### Contact between fan cover and hot air fan blades

#### DESCRIPTION:

Old fan

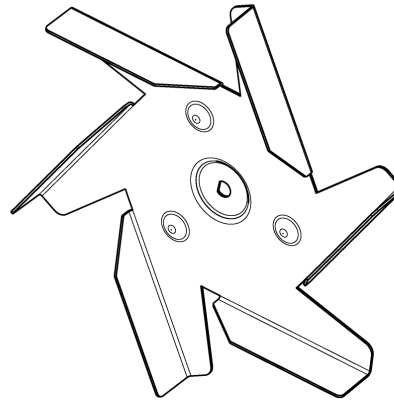
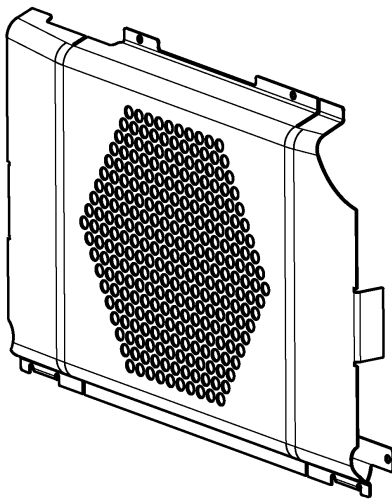
During usage of convection fan, hot air may cause deformation of fan cover. As a result, fan blades may start hitting the fan cover.

1. For PNCs listed in Table 1, it is required to install only new fan blades,
2. For PNCs listed in Table 2, it is required to install new fan blades and new fan cover.

Old fan	New fan
3152666214	3878453210
